**RE: 8004 Fuji Ct NW**  
**Grading and Drainage Plan**  
**Engineer's Stamp Date: 8/18/25**  
**Hydrology File: E10D088**  
**Case # HYDR-2025-00003**

Based upon the information provided in your submittal 1/9/2025, the Grading and Drainage Plan **is not approved** for Grading Permit and Building Permit. The following comments need to be addressed for approval of the above referenced project.

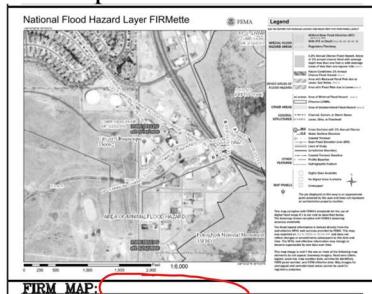
1. Typo for finished pad (FP) elevation – currently says FF. Please update.

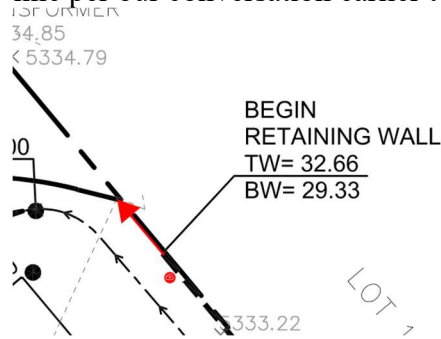
- Please extend retaining wall on the northeast side of the property to the 5334' contour line per our conversation earlier today.

- Per section 14-5-2-12(B)(2) of the Flood Hazard and Control Ordinances: *Construction, grading or paving on any lot within the jurisdiction of the city shall not increase the damage potential to upstream, downstream, or adjacent properties or public facilities. Damages shall be defined as those caused by flooding from the 100-year design storm and all smaller storms and from erosion and sedimentation resulting from the 10-year design storm and all smaller storms.* Is there an existing cross lot drainage easement? If not, you cannot drain onto the neighboring property without a clear agreement.

ENGINEER'S SEAL	<b>LOT 13 BLK 13 U 5 VC</b> <b>8004 FUJI CT. NW</b> <b>GRADING AND DRAINAGE PLAN</b>	DRAWN BY DEM
		DATE 10-8-20
8/18/25		SHEET # C1
DAVID SOULE P.E. #14522	1606 CENTRAL AVENUE SE SUITE 201 ALBUQUERQUE, NM 87106 (505) 872-0899	JOB #

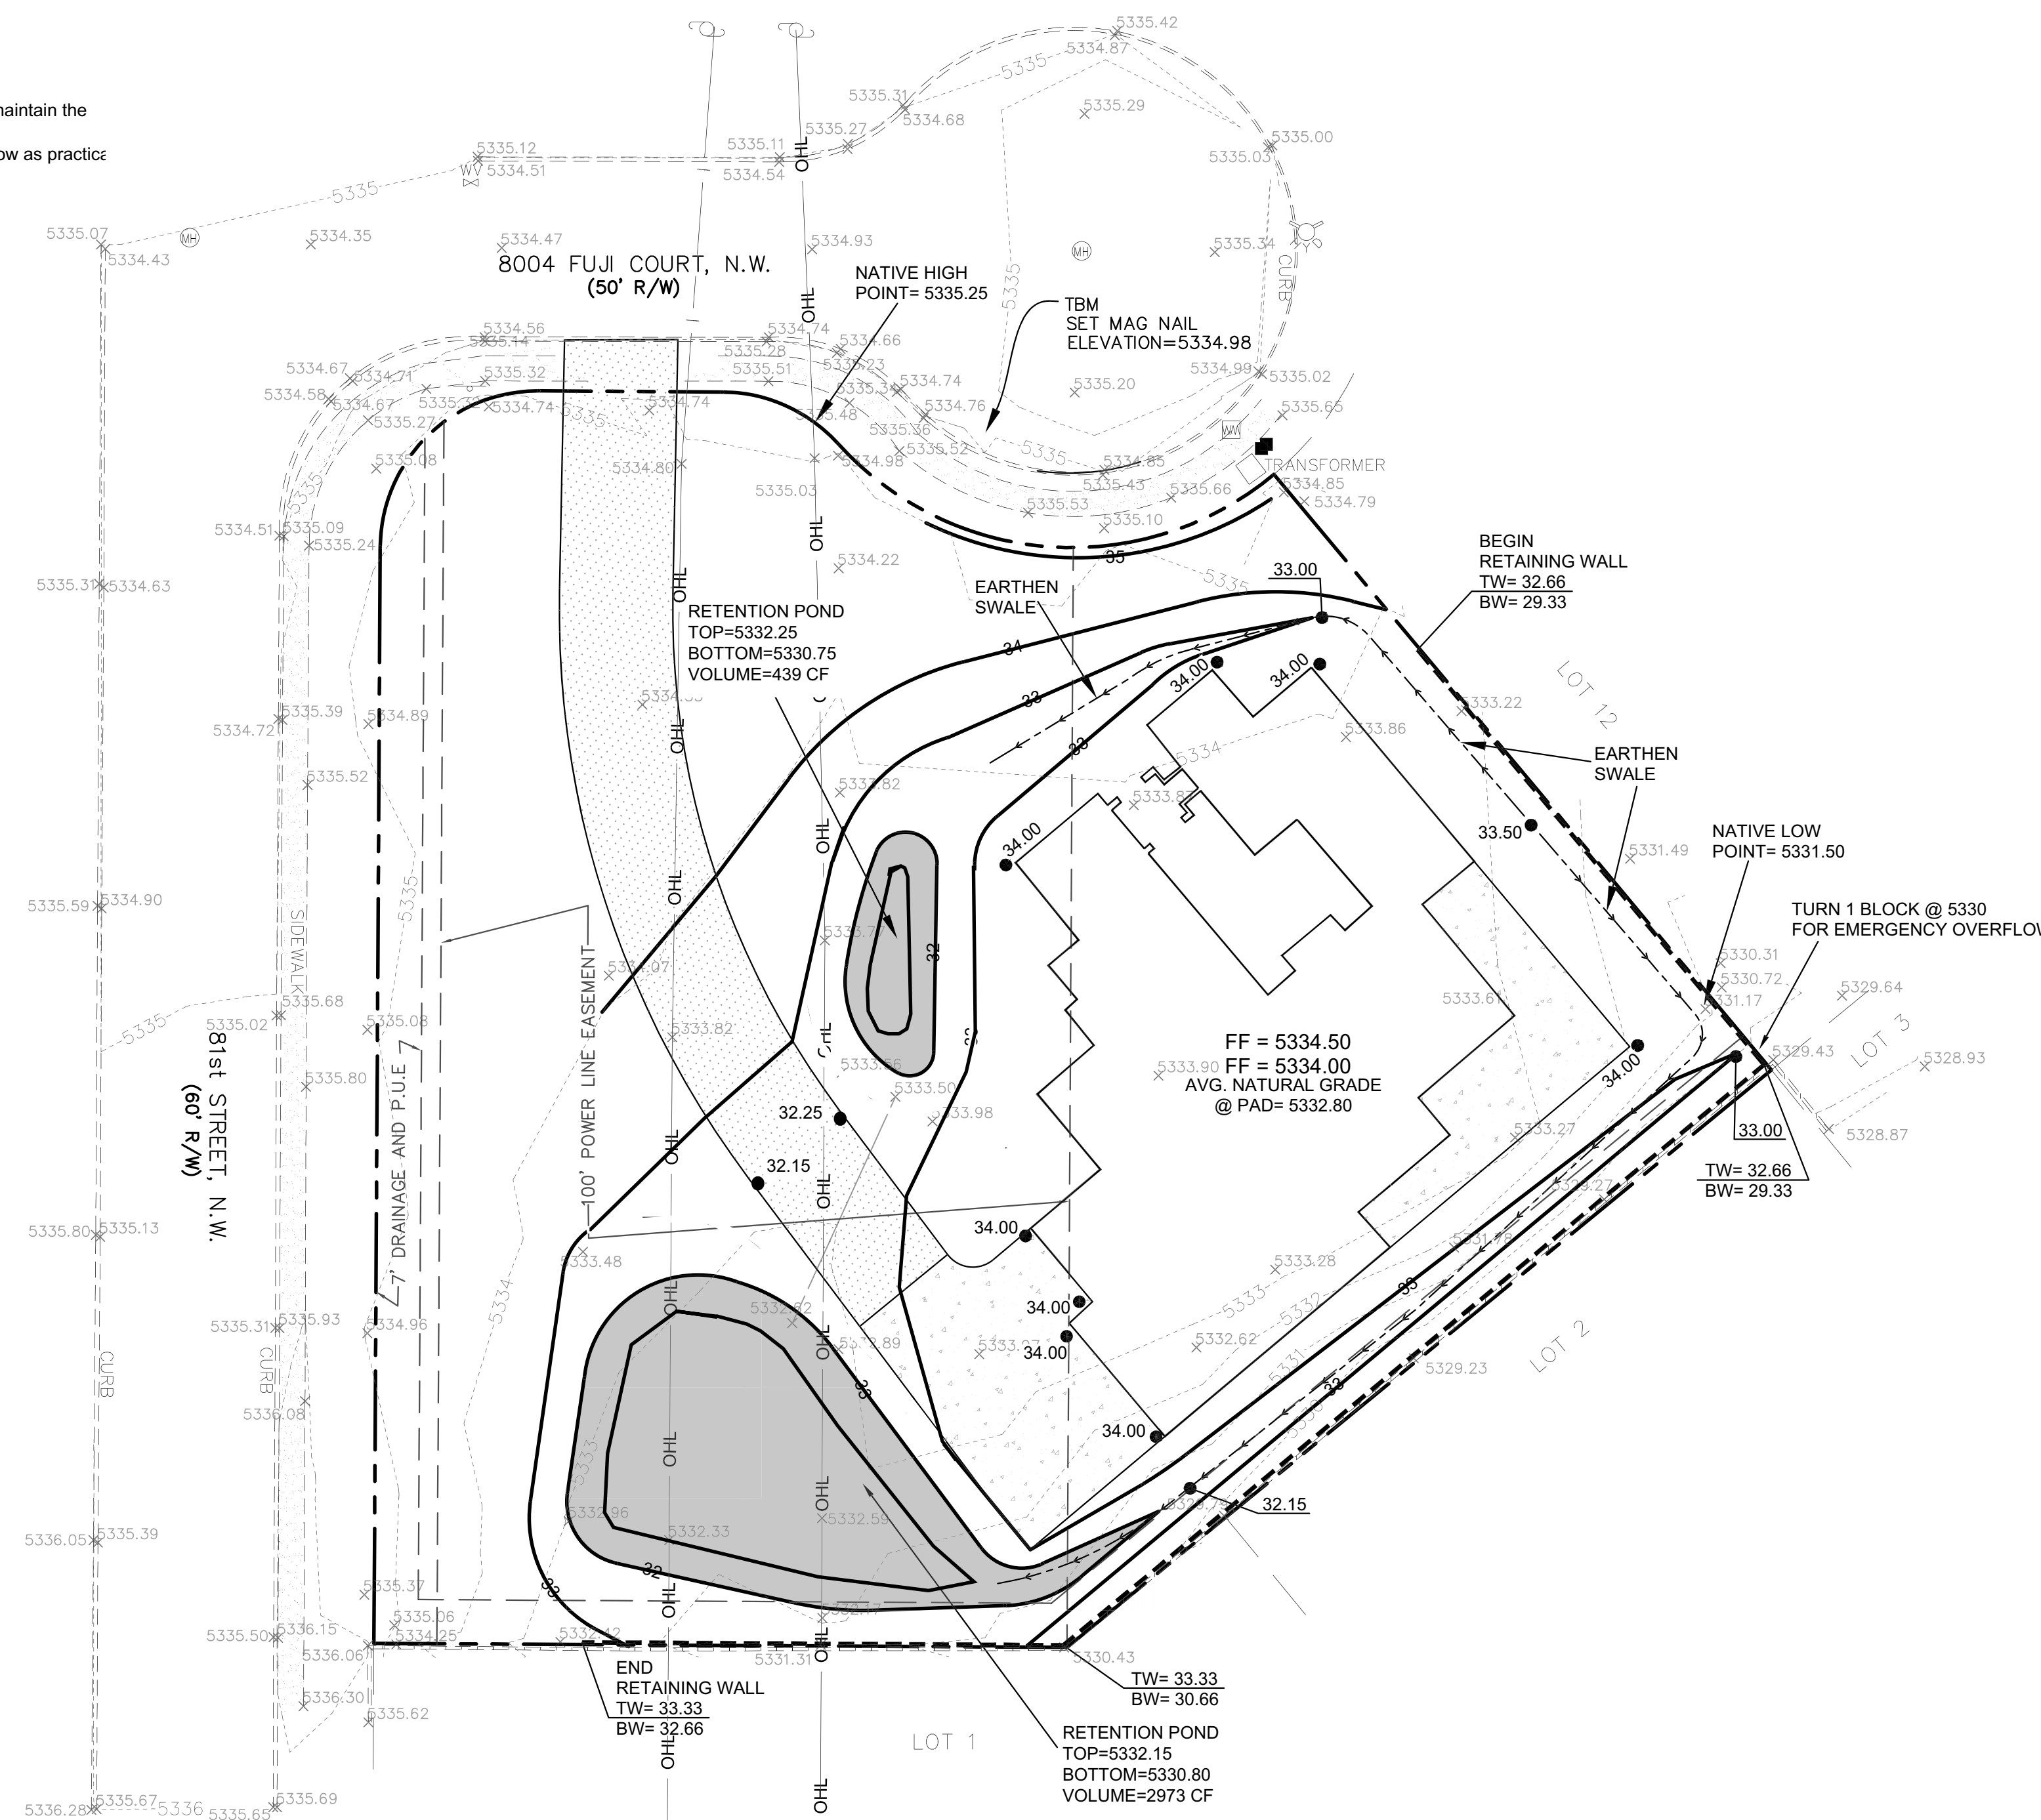
2. Please update the narrative to reflect SAD 227 instead of 228. Additionally, ponds are required and shown onsite in the plans.

3. Please provide the FIRM Map floodplain note with effective date.
